METROPOLITAN GOVERNMENT OF NASHVILLE AND DAVIDSON COUNTY

STAFF RECOMMENDATION
2002-2002 1/2 Eastland Avenue
October 15, 2014

Application: Demolition; New construction-infill
District: Eastwood Neighborhood Conservation Zoning Overlay
Council District: 06
Map and Parcel Number: 08306038400
Applicant: John Root, architect
Project Lead: Sean Alexander, sean.alexander@nashville.gov

SIDE ELEVATIONS

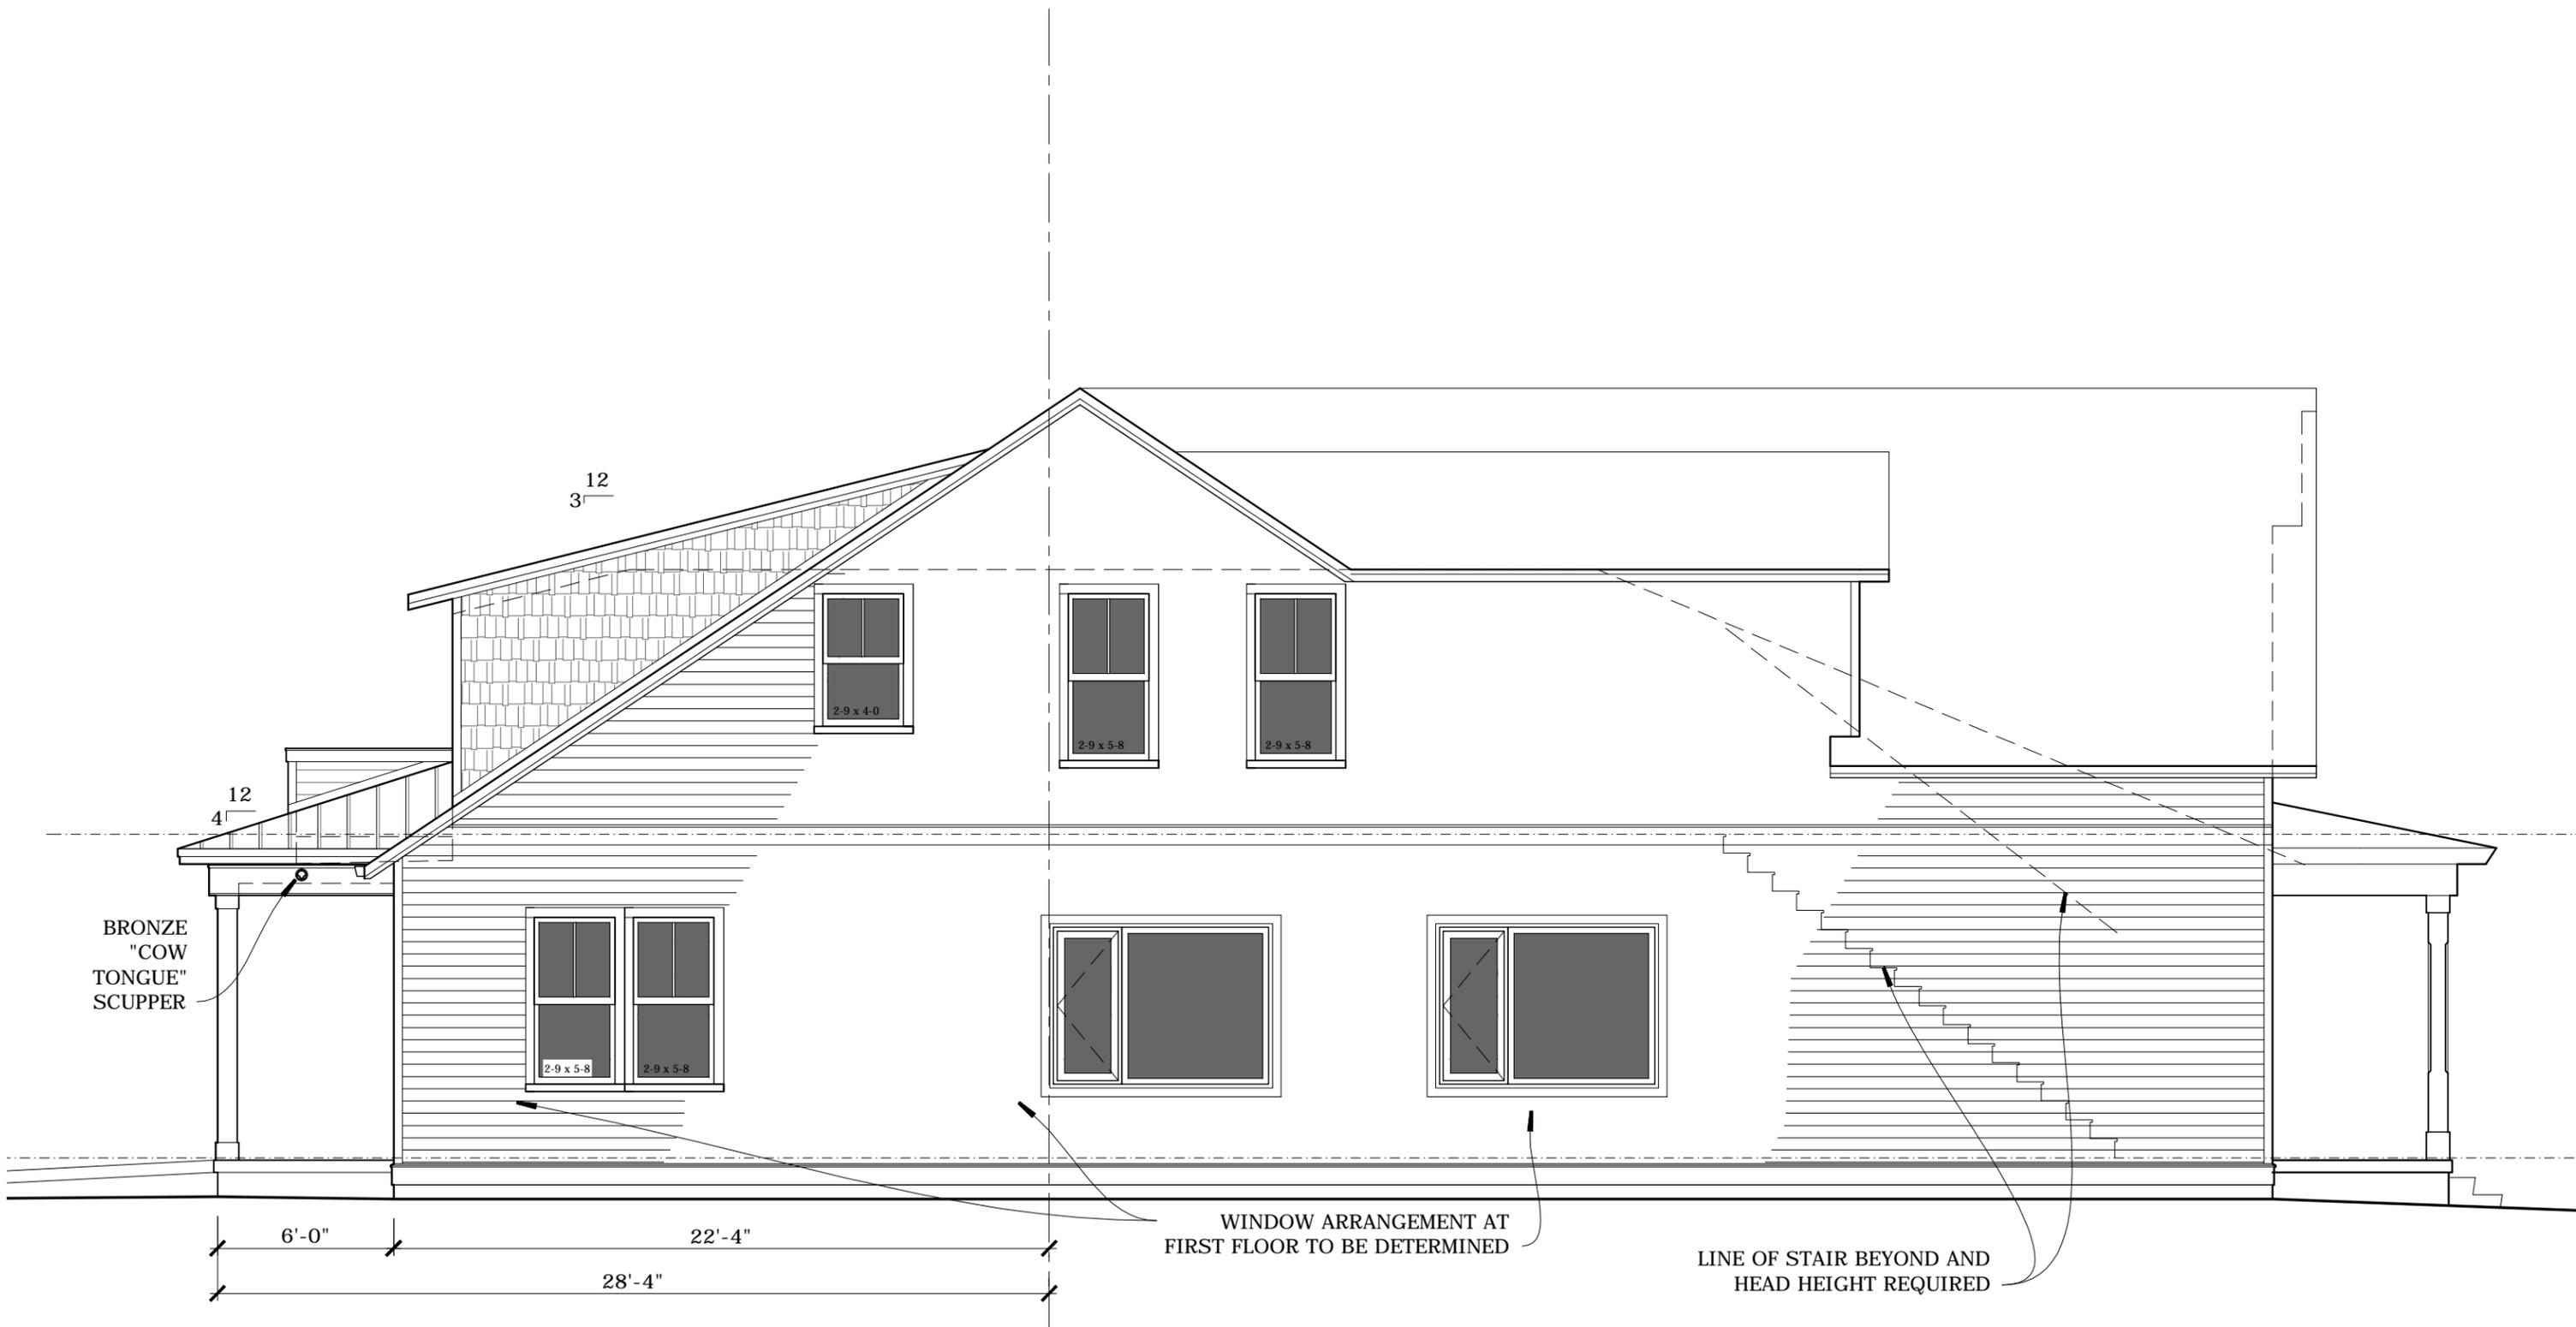
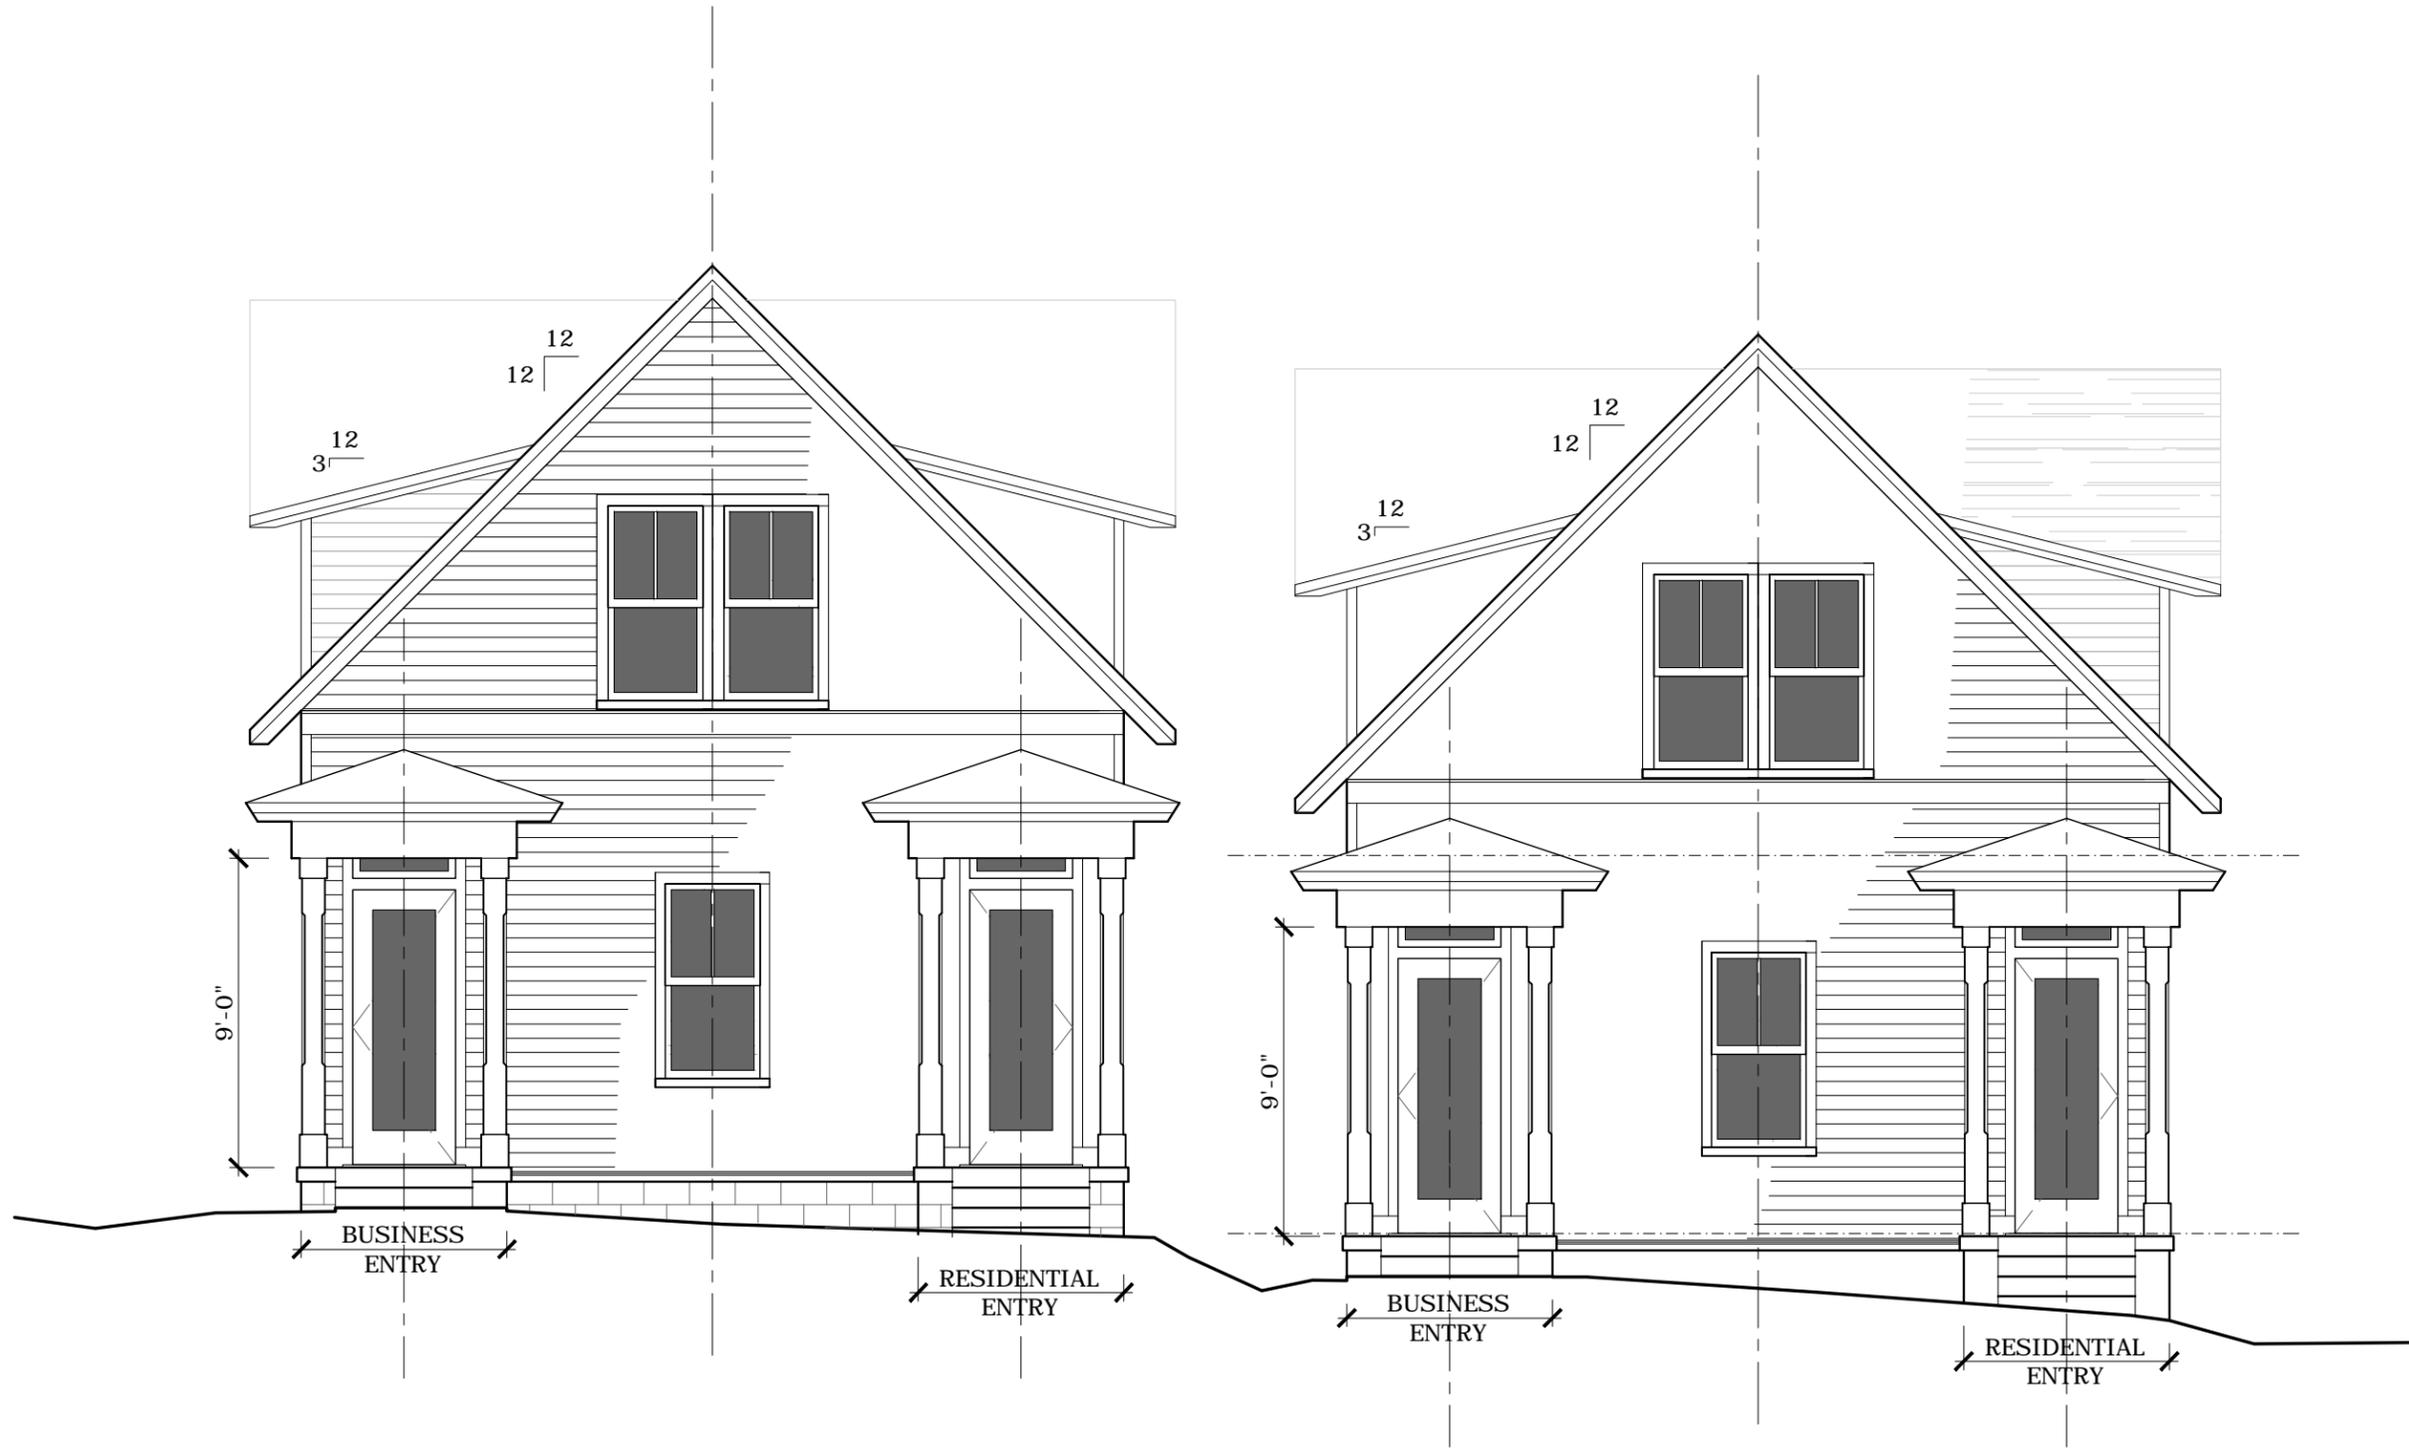
The front windows on the first story of the building will be commercial-type casements or fixed windows, and the upperstory windows and the side elevations will also have these windows, as well as side double-hung sash windows. The front windows are modern interpretations of a front "picture" window with two side-lights seen on some buildings as early as the 1930s and 1940. Although not generally appropriate for side elevations, the fixed and casement-type windows on these buildings will be at the rear and will not be greatly visible. Staff finds the project's proportion and rhythm of openings would meet Section II.B.1.g.
